DATE ~~R~~ Jun. 3/03**V2500-A1/A5 SERIES PROPULSION SYSTEMS SERVICE BULLETIN**

**V2500-ENG-73-0144**  
 Transmittal - Page 1 of 2

ENGINE FUEL AND CONTROL – FUEL NOZZLE – INTRODUCTION OF REVISED SUPPORT BRACKETS FOR  
THE TURBINE COOLING AIR PIPE

Existing Part No.	New Part No.
6A6559	6A7452

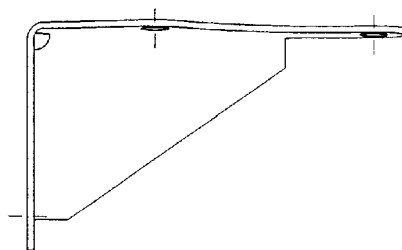
6A6559, Bracket - TCA No. 1, (Refer to 73-13-41, Fig/Item 01-120)

Bracket - Before and After Rework  
Figure 1

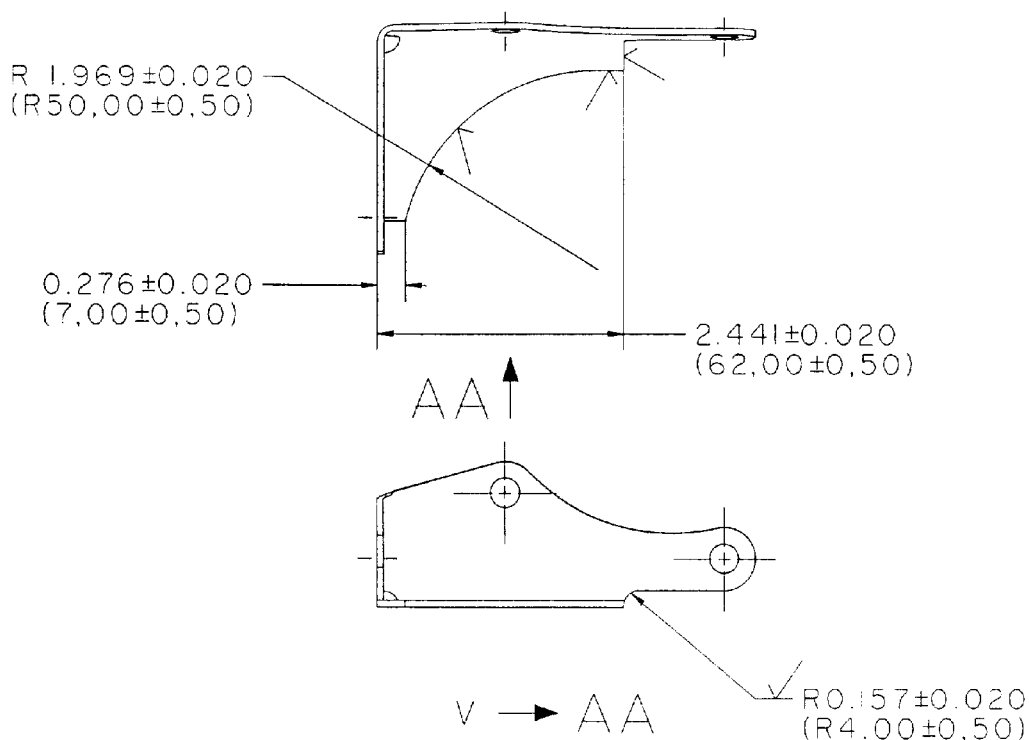
(1) The TCA No. 1 bracket has been revised, the changes introduced are as follows:

(a) The side adjacent to the fixing holes is scalloped.

(b) The length of the side adjacent to the fixing holes is reduced.

(3) The existing TCA No. 1 bracket can be reworked. (Refer to Figure 1).

PROCEDURE	RELATED DATA
(a) Chemically clean the bracket.	Use chemical cleaning equipment. Refer to the Standard Practices Manual (SPM), TASK 70-11-03-300-503.
(b) Apply marking ink in the area(s) of the bracket to be reworked.	Use standard workshop equipment. Refer to Fig 1.
(c) Mark off the area(s) of the bracket to be removed.	Use standard workshop equipment. Refer to Fig 1.
(d) Rework the bracket in the area(s) shown.	Use standard workshop equipment. Refer to Fig 1.
(e) Remove sharp edges.	Use standard workshop equipment. Refer to Fig 1.
(f) Chemically clean the bracket.	Use chemical cleaning equipment. Refer to the Standard Practices Manual (SPM), TASK 70-11-03-300-503.

- (g) Do a local penetrant crack test on the reworked area. Use CoMat 06-22 fluorescent penetrant, with penetrant crack test equipment. Refer to the Standard Practices Manual (SPM), TASK 70-23-05-230-501.
- (i) Reject the bracket if cracks are found.
- (h) Visually examine and measure the dimensions of the reworked area(s). Refer to Fig 1.
- (i) Cancel the existing part number and identify with the new part number. Use vibro-engraving equipment. refer to the Standard Practices Manual (SPM), TASK 70-09-00-400-501, SUBTASK 70-09-00-400-001.

DIMENSIONS ARE IN INCHES (MILLIMETRES).  
MACHINE WHERE MARKED ✓  
SURFACE FINISH TO BE 125 MICROINCHES (3.2 MICROMETRES) UOS.  
BREAK SHARP EDGES 0.012±0.008 (0.30±0.20).
